**MINOR HISTORIC DESIGN REVIEW CASE NO.: HIS20-21**

**SUMMARY:** A proposal to add two metal chimney straps on the exterior of the Warren Carkin House chimney (c. 1920).

**HISTORIC DESIGN REVIEW CASE NO. HIS20-21  
DECISION**

Chimney on Eastern Façade of Carkin House

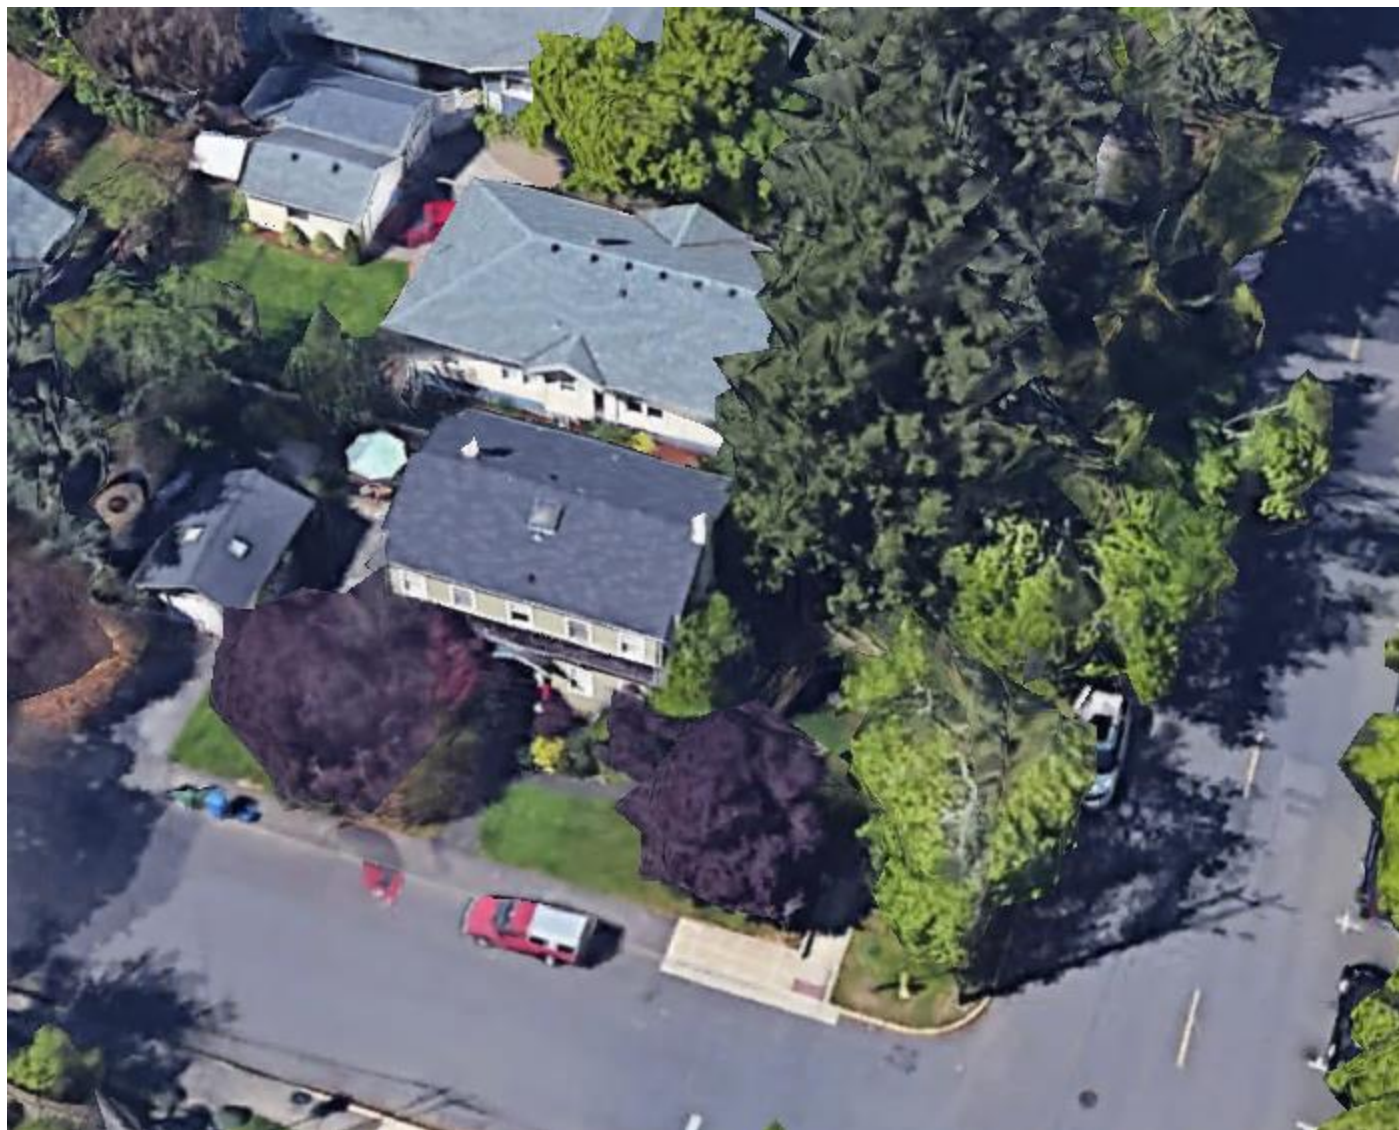
**Finding:** The applicant is proposing to install metal strapping in two locations, at the top of the upper floor, and near the peak. The strapping will be bent around the chimney and then lag bolted into the framing/rafters which will minimally impact the original siding on this façade. However, overall, this impact is minimal, and the original siding will be maintained to the maximum extent possible. Staff finds that SRC 230.025(g)(1)(D) has been met.

**Finding:** The applicant is proposing to install the chimney straps on the exterior of the chimney, which is located on the eastern façade of the Carkin House. This façade is a

secondary façade, thereby minimizing any adverse visual impact due to this alteration. Staff finds that SRC 230.025(g)(2)(A) has been met.

**Finding:** The applicant's proposal will result in the loss of a small amount of original siding, however this loss is minimal and will result in securing the chimney to the structure which will ensure that the overall form of the chimney is retained during a seismic event, further ensuring this character defining feature of the Carkin House is preserved. Staff finds that SRC 230.025(g)(2)(G) has been met.
